Technical Service Bulletin

Subject: WRONG VEHICLE LOCATION IN GPS WITH DTCS B119F:01, B119F:13 AND/OR B119F:2B STORED	Bulletin No.: 09-021/20
	Last Issued: 12/10/2020

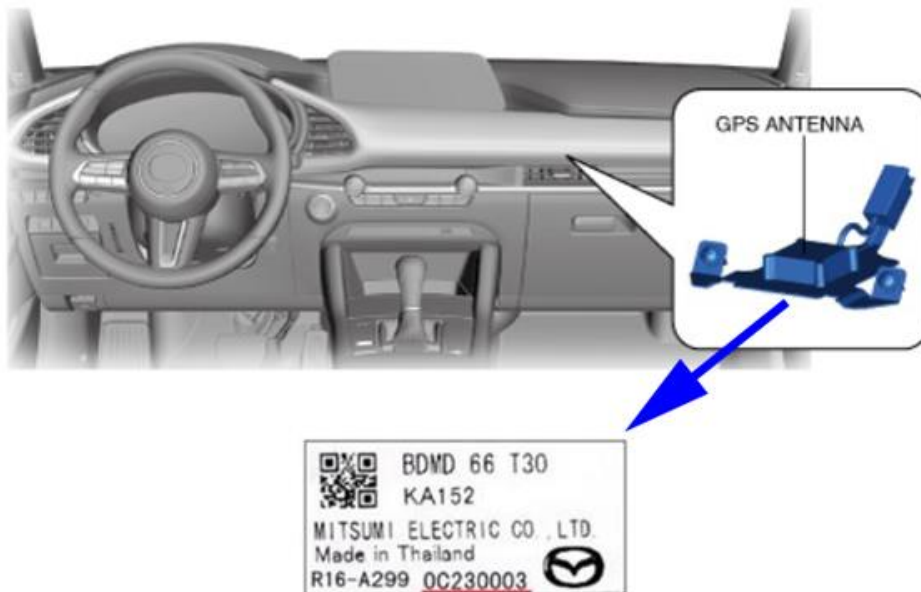
1. Verify customer concern.
2. Confirm if the telephone antenna No.1's lot number is before 0C230003. The lot number is in YMDDnnnn format.

NOTE: The part number has not been changed for this modification.

- If the lot number is 0C230003 or later, the part is already modified.
- If the lot number is before 0C230003, replace the GPS antenna with a modified one by referring to the instructions on MGSS.
 - Mazda3: (GLOBAL POSITIONING SYSTEM (GPS) ANTENNA REMOVAL/INSTALLATION)
 - CX-30: (GLOBAL POSITIONING SYSTEM (GPS) ANTENNA REMOVAL/INSTALLATION)
